## **Air Quality Permitting Statement of Basis**

**Tier I Operating Permit No. T1-2010.0030**

**Clearwater Paper Corporation, Lewiston**

**Pulp and Paper Division**

Figure 1. No. 4 Recovery Furnace Test Data

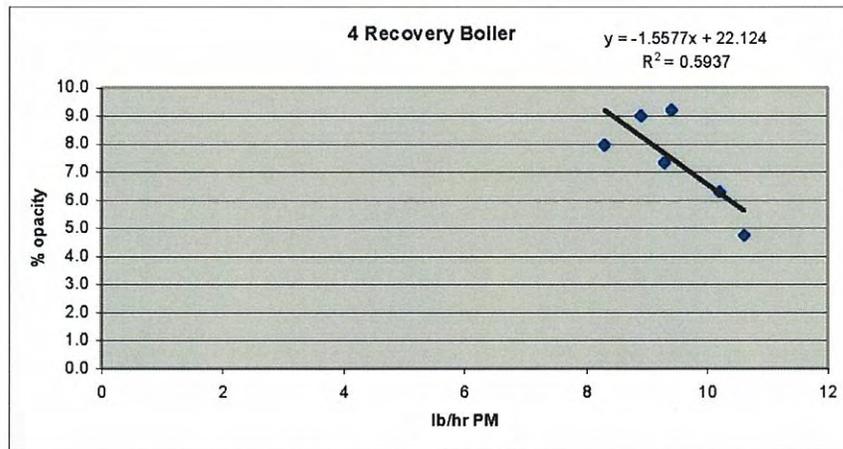
As shown in Figure 1, there is no reliable statistical correlation between opacity and PM emissions. However, that data do show that at an opacity range up to 46% of the proposed indicator range (9.2% opacity), maximum PM emissions are only 29% of the constraining PM limitation. PM emissions from ESP controlled recovery furnaces are comprised of mostly very small particles, less than 2.5 microns.<sup>1</sup> These small particles create higher opacity levels than do emissions of larger particles for the same mass concentration levels. Based on this fact and the available test data, it can be concluded that opacity at PM emission rates equal to or greater than the applicable limits would likely be above the proposed 20% indicator range. Therefore, the proposed indicator range, consistent with MACT Subpart MM requirements, will provide a reasonable assurance of compliance with all applicable PM limitations on the No. 4 Recovery Furnace.

Figure 2. No. 5 Recovery Furnace Test Data

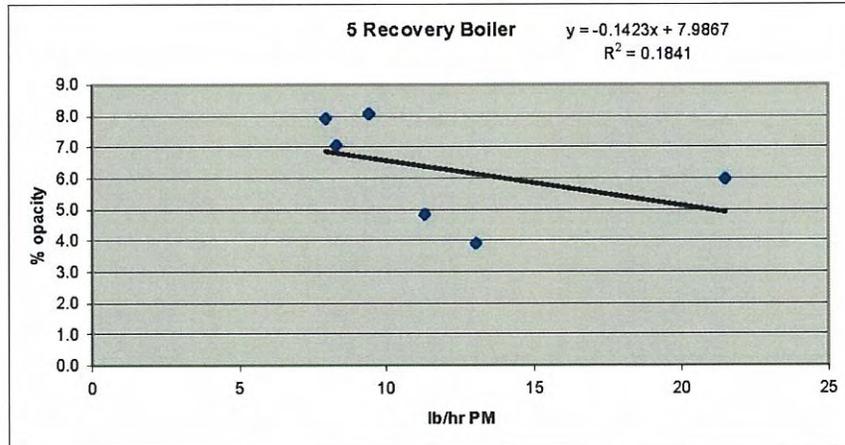
As shown in Figure 2, there is no reliable statistical correlation between opacity and PM emissions. However, that data do show that at an opacity range up to 40% of the proposed indicator range (8.1% opacity), maximum PM emissions are only 33% of the constraining PM limitation. PM emissions from ESP controlled recovery furnaces are comprised of mostly very small particles, less than 2.5 microns.<sup>3</sup> These small particles create higher opacity levels than do emissions of larger particles for the same mass concentration levels. Based on this fact and the available test data, it can be concluded that opacity at PM emission rates equal to or greater than the applicable limits would likely be above the proposed 20% indicator range. Therefore, the proposed indicator range, consistent with MACT Subpart MM requirements, will provide a reasonable assurance of compliance with all applicable PM limitations on the No. 5 Recovery Furnace.

**Figure 3. No. 3 Lime Kiln Test Data (Continued)**

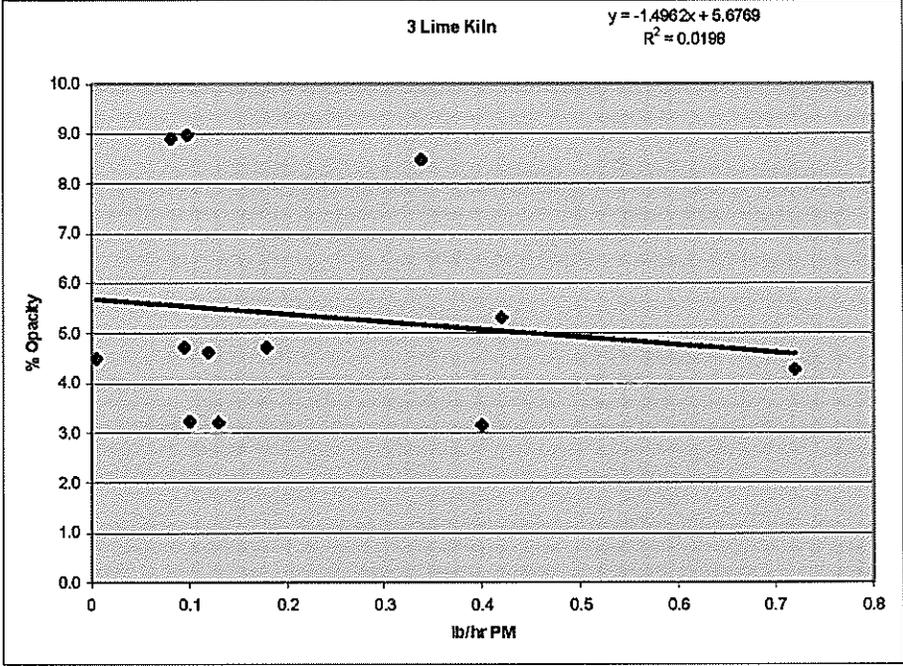
As shown in Figure 3, there is no reliable statistical correlation between opacity and PM emissions. However, that data do show that at an opacity range up to 45% of the proposed indicator range (9.0% opacity); maximum PM emissions are only 8% of the constraining PM limitation. Based on this it can be concluded that opacity at PM emission rates equal to or greater than the applicable limits would likely be considerably above the proposed 20% indicator range. Furthermore, the Nos. 3 and 4 Lime Kilns are essentially identical, with identical ESP control systems, and the No. 4 Lime Kiln test data did show a positive correlation between opacity and PM emissions (see No. 4 Lime Kiln CAM Plan). Applying the correlation from the No. 4 Lime Kiln, PM emissions at 20% opacity equate to 3.5 lb/hr vs. the constraining applicable limit of 5.2 lb/hr. Therefore, the proposed indicator range, consistent with MACT Subpart MM requirements, will provide a reasonable assurance of compliance with all applicable PM limitations on the No. 3 Lime Kiln.

Figure 4. No. 4 Lime Kiln Test Data

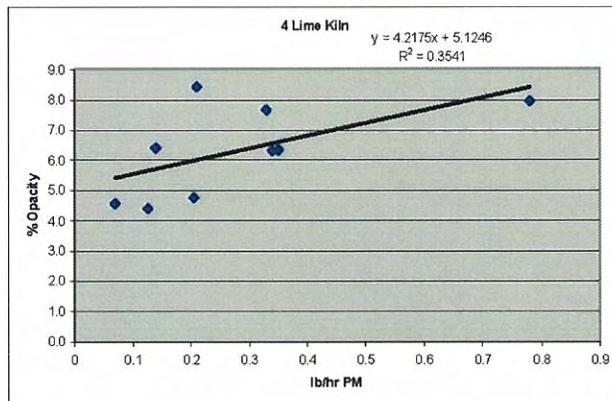
As shown in Figure 4, there was a positive correlation between opacity and PM emissions. Applying the correlation, PM emissions at 20% opacity equate to 3.5 lb/hr vs. the constraining applicable limit of 5.2 lb/hr. Therefore, the proposed indicator range, consistent with MACT Subpart MM requirements, will provide a reasonable assurance of compliance with all applicable PM limitations on the No. 4 Lime Kiln.
